Our Ref: 110419-11-Lot 8-SOFAC Response Letter.docx
DC:tm

**Subject: Land and Environment Court Appeal (Case No. 2019/376150)
Letter of Advice – Lot 8**

We refer to the Land and Environment Court Appeal (Case No. 2019/376150) where Council has raised several concerns with the proposed development application (DA-18-00159) for the future residential development at Lot 8, 1070-1082 Richmond Road, Marsden Park.

Plate 1 - MUSIC Catchments and Areas

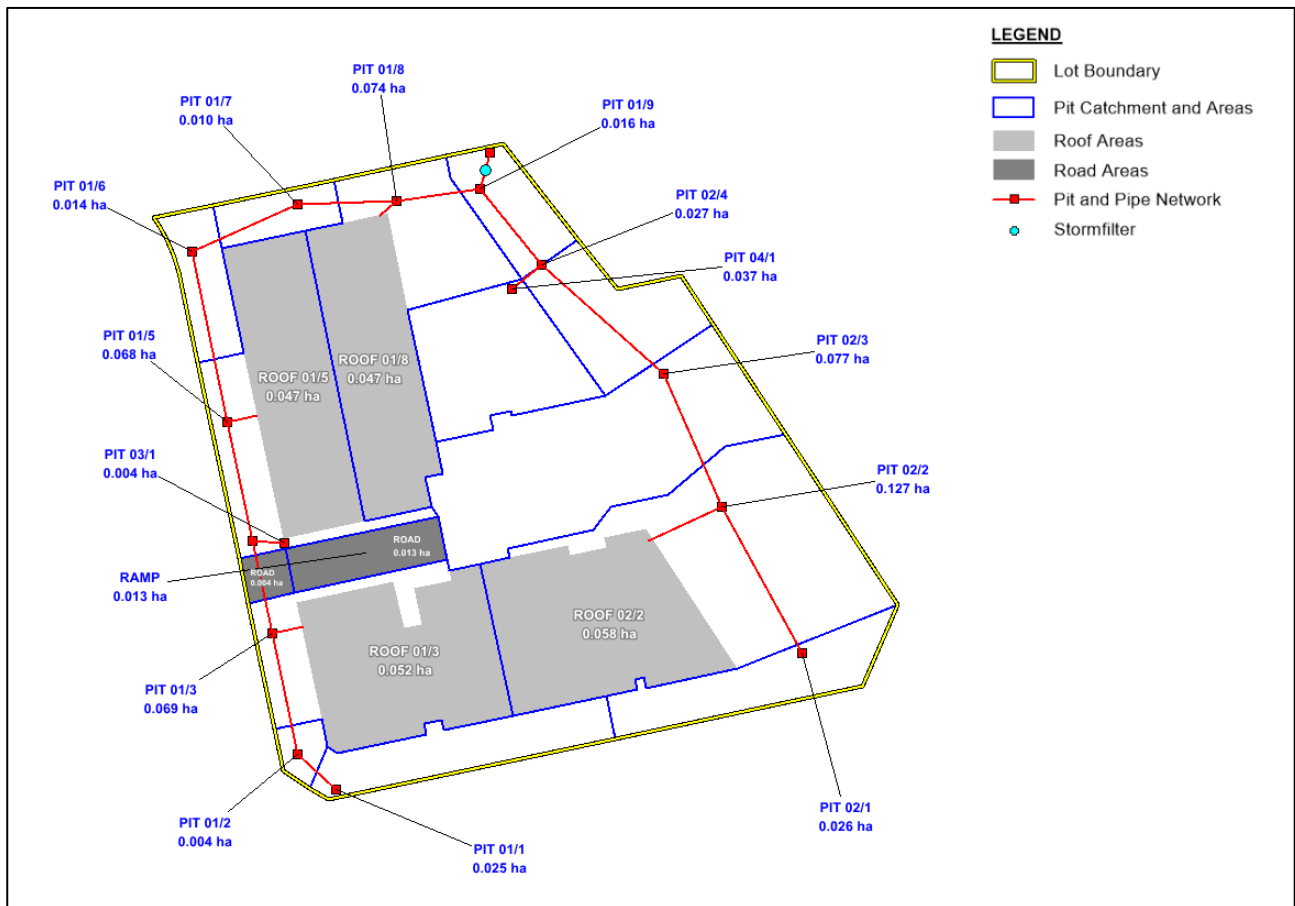
Contention 9.1

Revised MUSIC modelling is required to ensure that the water quality targets are achieved on the subject lot.

Contention 9.2

Provide a MUSIC catchment plan showing all areas of bypass.

The MUSIC assessment has been revised. As a result, roof and private road areas have been determined based on the current architectural layouts of the proposed development product (ref: 20/08/2020).

See Table 1 and Plate 1 below for a summary of the areas used in the MUSIC model.

Refer to Plate 1 above for details of the MUSIC model breakup which reflects the catchments draining to each surface inlet pit within the site. Refer to the engineering drawing set 11041911DA421-430 for further details of the drainage network.
